2210 EASTLAKE AVENUE EAST

#3036247-EG, 3036179-LU Project #:

Administrative Design Review (ADR) Recommendation Packet

1) Pedestrian View Looking Northeast from Eastlake Avenue East

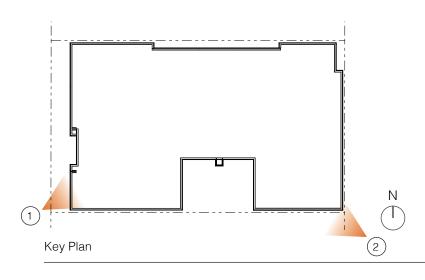
The applicant indicates that there is a Exceptional 20" Common Hawthorn tree on the north side of the property to the south. The canopy of this tree extends over the subject property. The excerpt from the arborist's report included in the EDG packet indicates that the drip line is 12' and the inner root zone is 6'. With the Master Use Permit (MUP) application, upload the full arborist's report, include the following information and incorporate the following guidance:

- a. Identify the location of the critical root zone on this site and show the tree protection area on the site and floor plans.
- b. If it is found that the tree will be significantly impacted by the proposed design and substantial modifications are required to the design proposal, the applicant may have to return for EDG guidance.

- The arborist report has been included in the Master Use Permit application, refer to Sheet A0.16. The report's recommendations for the tree protection areas have been incorporated into the plans and the proposed structure does not impede on those areas. The exceptional 20" Common Hawthorn, which is south of the project's southern property line, has a tree protection area in the southwest corner of the project site which has been accommodated for in the proposed design. The western most portion of the south facade modulates at the ground floor and first floor in order to provide an adequate buffer for the exceptional tree.

1 Section Perspective Looking South through Alley Unit 102

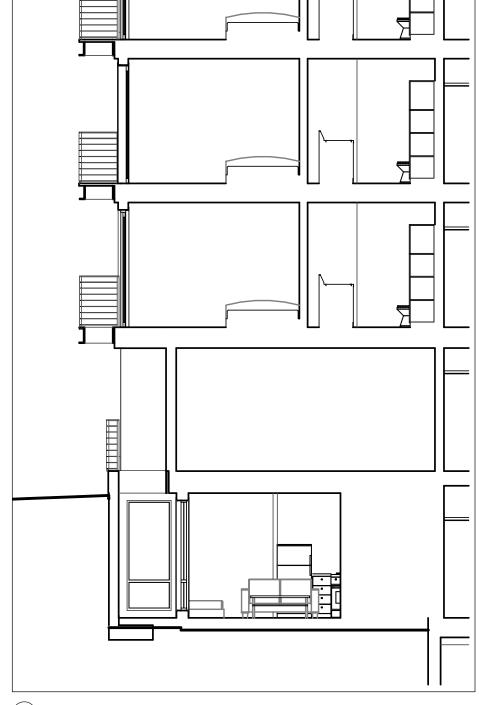
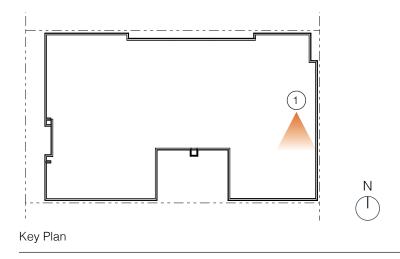
- d. It is unclear from the building sections provided in the EDG packet if the ground level residential units facing the alley are set back from the property line. Clarify if there are belowgrade units with light wells. If this is the case, provide further information showing the height, width and depth, and the condition along the edge of the alley. PL3-B-1, PL3-B-2

- The arborist report has been included in the Master Use Permit application, refer to Sheet A0.16. The report's recommendations for the tree protection areas have been incorporated into the plans and the proposed structure does not impede on those areas. The exceptional 20" Common Hawthorn, which is south of the project's southern property line, has a tree protection area in the southwest corner of the project site which has been accommodated for in the proposed design. The western most portion of the south facade modulates at the ground floor and first floor in order to provide an adequate buffer for the exceptional tree.

1 Aerial Looking Northeast

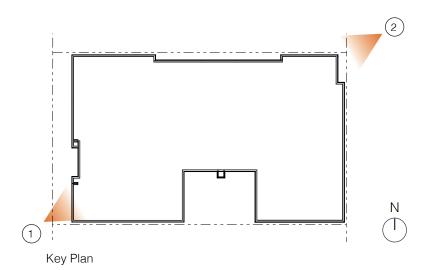
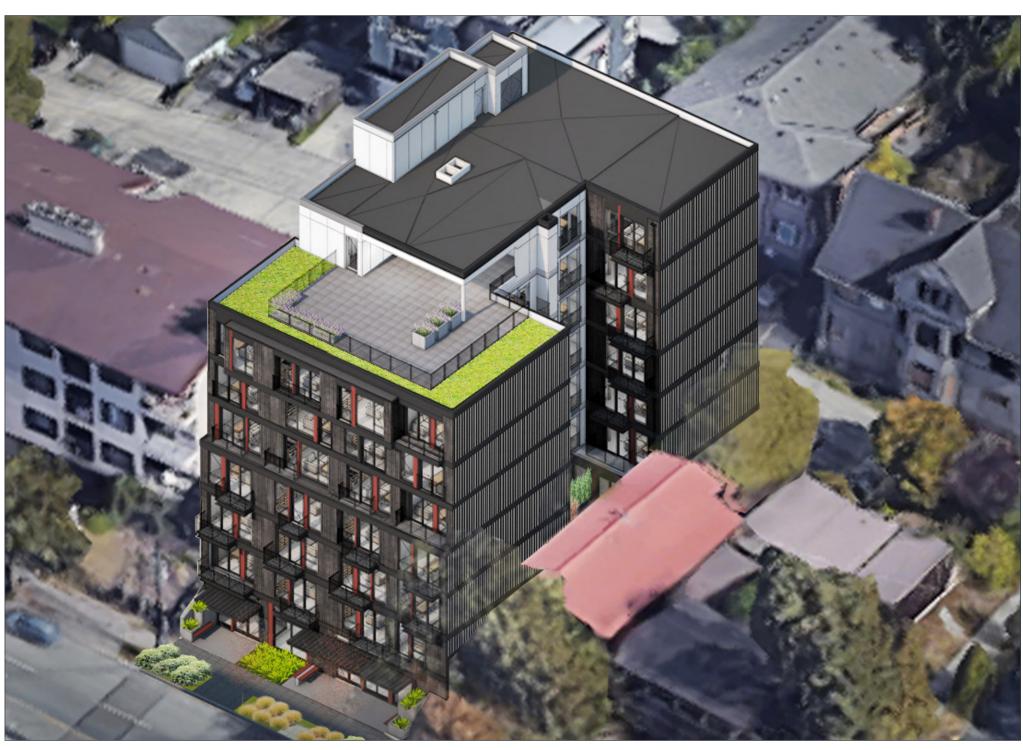
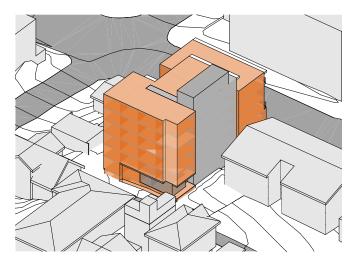
Staff acknowledges the complexity of the site; its existing context and zoning, the single-story historic character building to south, the grade difference from the street to the alley; and appreciates the initial moves made to address them in Massing Options 2 and 3. Staff does not support the development of Massing Option 1. Moving forward, Staff recommends developing either Massing Option 2 or 3, with the following guidance:

- a. Further develop the horizontal modulation and articulation implied in this option. Provide architectural parti and concept diagrams.
- b. The visible vertical circulation cores should be integrated into the overall building massing concept. Study ways in which to reduce the perceived height, bulk, and scale of this element by extending the same material treatment from the west side over the core, reducing the visible core height to 2 stories. The step on the two-story penthouse box helps reinforce the top floor setback.
- c. Delete the notches along the south property line.

- The design team chose to develop and move forward with Alternative 3. The design has explored massing, material articulation, and secondary architectural features, as a way of incorporating a holistic design concept that is further described in section 3 below. The vertical circulation core is expressed as a single mass and is differentiated from the rest of the north facade by change in plane. The massing moves are further articulated by a change in materiality, breaking down the overall height, bulk, and scale of the north facade. The notches at the south property line are responsive to the required Tree Protection Area for the neighboring exceptional trees described in the Arborist report. This modulation is minimal and only expressed at the ground floor and the first floor. The visibility of this modulation will be mostly covered by existing and new vegetation proposed on the site.

(1) Pedestrian View Looking Northeast from Eastlake Avenue E

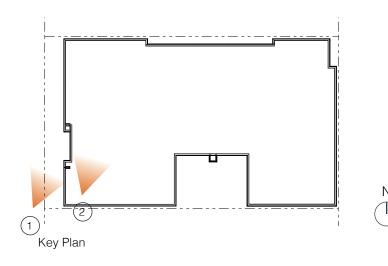
- a. The residential lobby and commercial entrance are set back from the sidewalk edge well beyond the rockeries at the north and south properties and will not be easily seen when approaching from the north and south. Integrate elements such as canopies and other architectural features that will help enhance the entry sequence and wayfinding. This street frontage should remain transparent as indicated on the floor plans for both options 2 and 3. PL2-B-1, PL3-B-2, PL3-B-3, PL3-B-4

- b. It is unclear from the site plans provided for option 2 and 3 in the EDG packet how the area in front of the residential lobby and commercial spaces will be treated. The design of this space and the facades should encourage interaction and activation of the street. Study ways to incorporate seating and other elements that promote interaction. CS2-B-2, PL1-A-2, PL1-B-3, PL3-A-1, PL3-C

- The street-level street-facing facade incorporates canopies that highlight the residential and commercial entries and wayfinding. The street frontage has remained transparent by incorporating large areas of glazed storefront into the design. Low planters will be used to stitch the recessed entry to the adjacent grade. PL2-B-1, PL3-B-2, PL3-B-3, PL3-B-4
- The proposed design provides a dynamic and engaging streetscape by incorporating planters, canopies, seating, and transparency of the facade. The planters terrace from the retaining wall, providing a softening transition from the slope along the Eastlake Ave E. The configuration of these terraced planters create a public space in front of the structure. This space is required by code based on the width of the existing Eastlake Avenue E right-of-way. CS2-B-2, PL1-A-2, PL1-B-3, PL3-A-1, PL3-C

3 Section through the Streetscape and Street Front

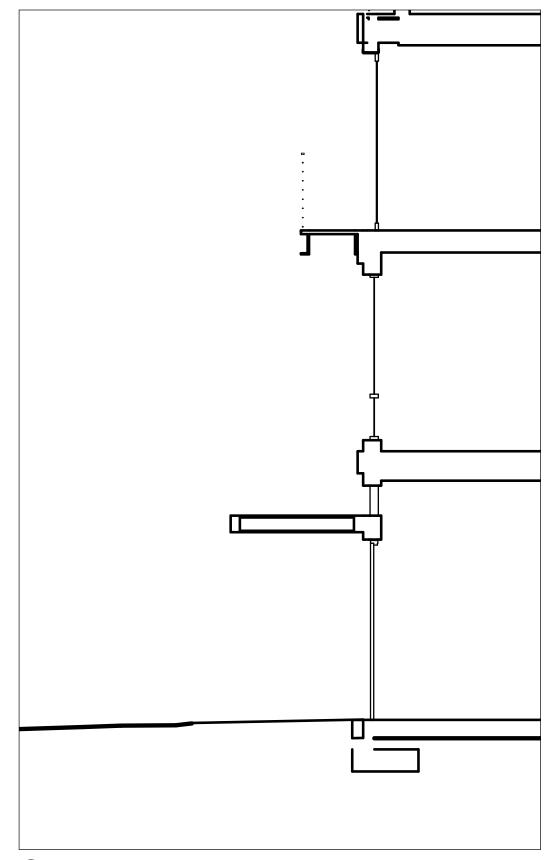
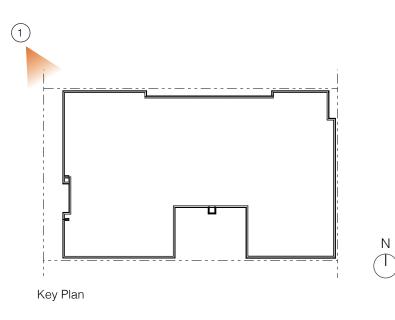
- c. Because of the SDOT required setback along Eastlake Ave E, work with SDOT and the landscape architect to make a gentle transition from the rockeries at the north and south ends of the site. Avoid tall retaining walls if possible. CS1-C-1, CS2-D-2

- The project proposes a gentle transition from the rockeries and slopes to the north and south of the site. As described above, retaining walls follow the slope and transition to low planters along the sidewalk. CS1-C-1, CS2-D-2
- The project proposed two units that are below the alley level. The units are set back from the east property line at the alley in order to incorporate private patios which also serve as light wells for the units. The provided sections in the plan set demonstrate the dimensional conditions of these units. PL3-B-1, PL3-B-2
